The Commission has issued the enclosed Amendment No. 17 to Facility Operating License No. DPR-53 for the Calvert Cliffs Nuclear Power Plant Unit No. 1. The amendment consists of a change in the Technical Specifications in accordance with your application dated July 15, 1976.

AMENDMENT TO FACILITY OPERATING LICENSE

Amendment No. 17
License No. DPR-53

SAFETY EVALUATION BY THE OFFICE OF NUCLEAR REACTOR REGULATION
SUPPORTING AMENDMENT NO. 17 TO FACILITY OPERATING LICENSE NO. DPR-53

Figure
3-6

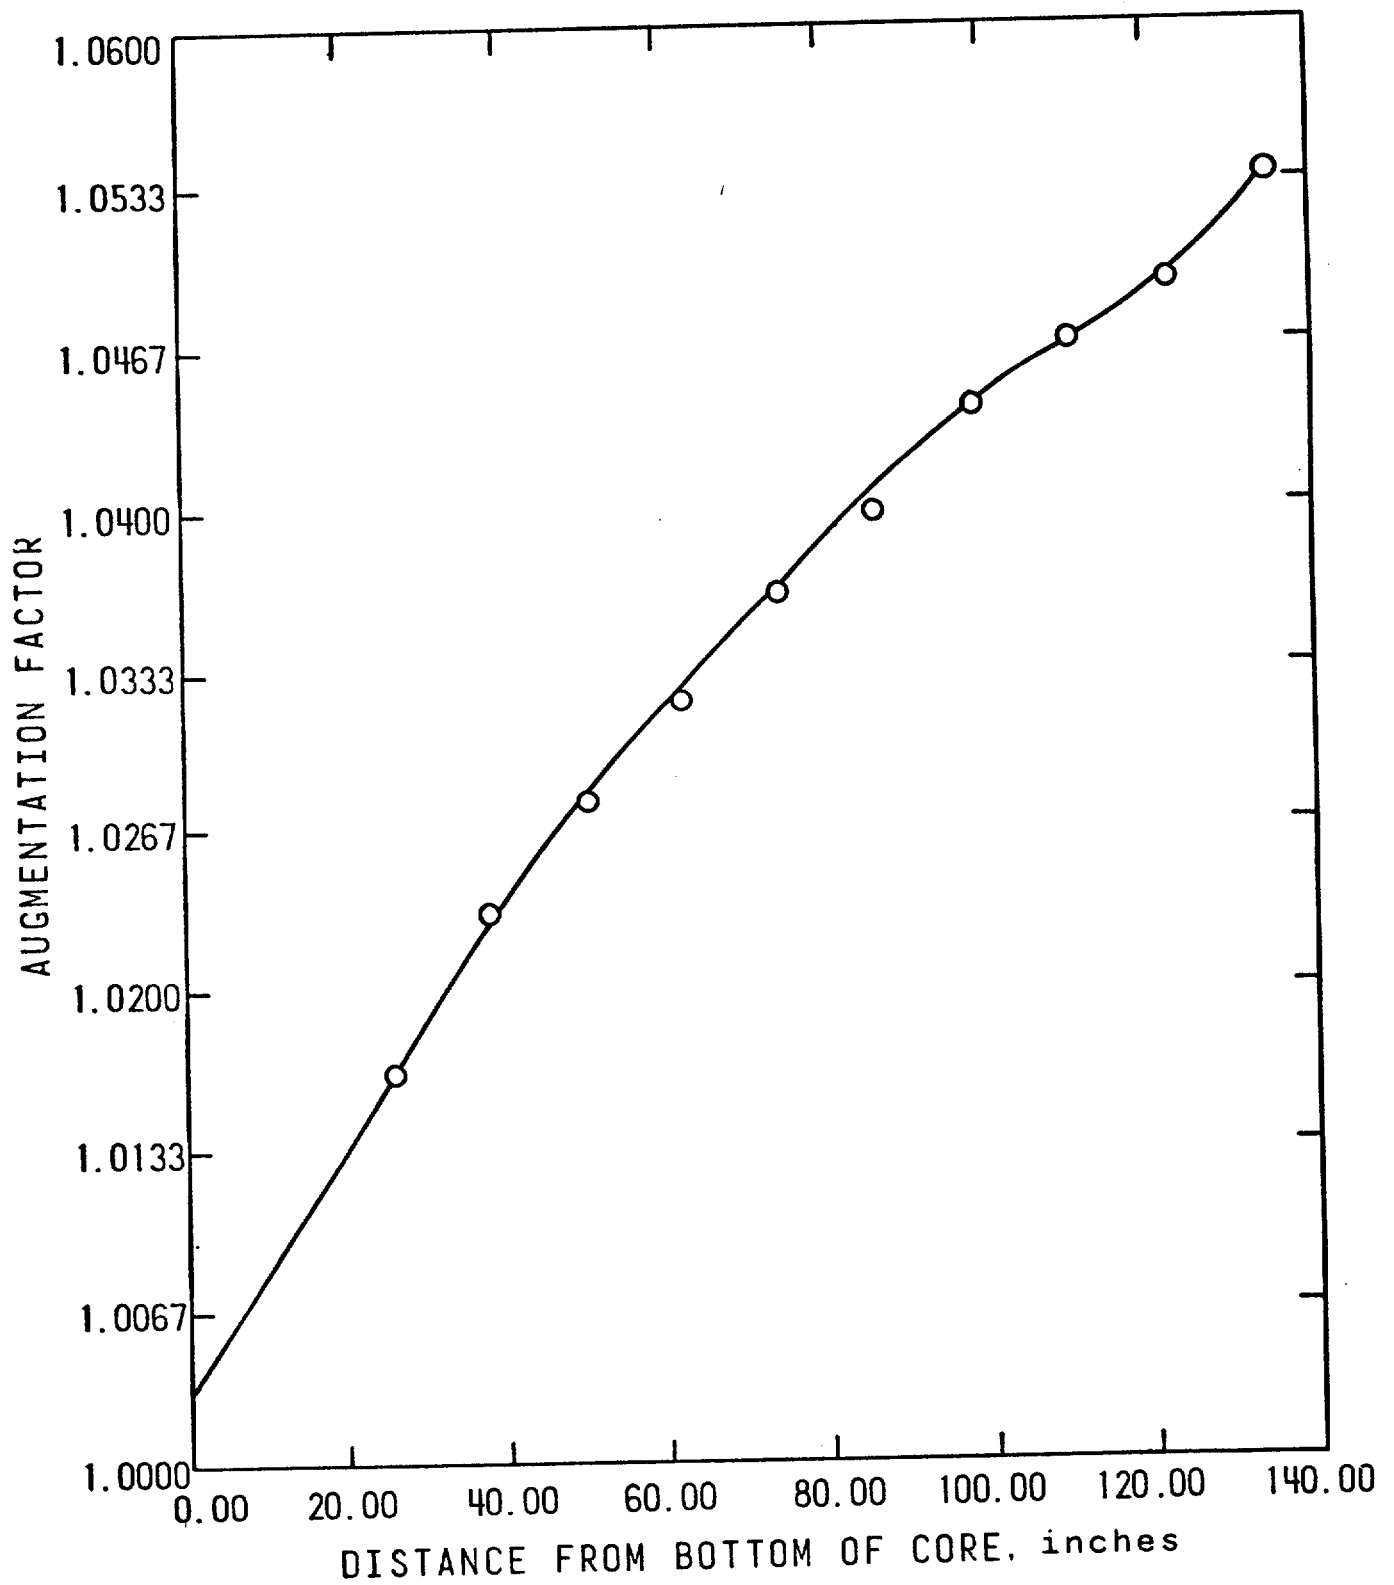
This amendment modifies the Technical Specifications to incorporate a revised Figure 3-6 "Augmentation Factors for the Calvert Cliffs Reactor". This results in an effective gain of approximately 0.7 kW/ft in the operating margin to the maximum allowable peak linear heat generation rate.

Replace page 3.10-20 (Figure 3-6) of the Appendix A portion of the Technical Specifications with the enclosed revised page 3.10-20.

The augmentation factor accounts for power peaking due to fuel densification effects and influences the maximum allowable peak linear heat generation rate (PLHGR). As a result of errors found in the Combustion Engineering Loss-of-Coolant-Accident (LOCA) heatup code, STRIKIN-II, the PLHGR for Calvert Cliffs Unit No. 1 was reduced to 13.9 kW/ft and reaffirmed by Confirmatory Order dated June 17, 1976. The PLHGR limit includes an interim penalty of 1 kW/ft until additional calculations are approved by the NRC. The licensee has stated that the proposed Figure 3-6, which is a reduction in augmentation factor, will result in an effective gain of approximately 0.7 kW/ft in the operating margin to the maximum allowable PLHGR.

We have reviewed the proposed curve of Figure 3-6. The proposed curve relating augmentation factor versus distance from the bottom of the core was generated using the methods described in the Combustion Engineering Topical Report, CENPD-139, for densification. The proposed curve is the same as the curve recently reviewed and approved by the staff for use in the Technical Specifications for Calvert Cliffs Unit No. 2. Augmentation factors were determined for various values of fuel burnup for the full life of the fuel in both Calvert Cliffs Unit Nos. 1 and 2.

The final proposed augmentation factor curve was defined as shown on Figure 3-6 by combining the most conservative values taken from both sets of calculations. We conclude that the change in augmentation factor as shown in Figure 3-6 has been determined using accepted and conservative methods and, therefore, is acceptable.
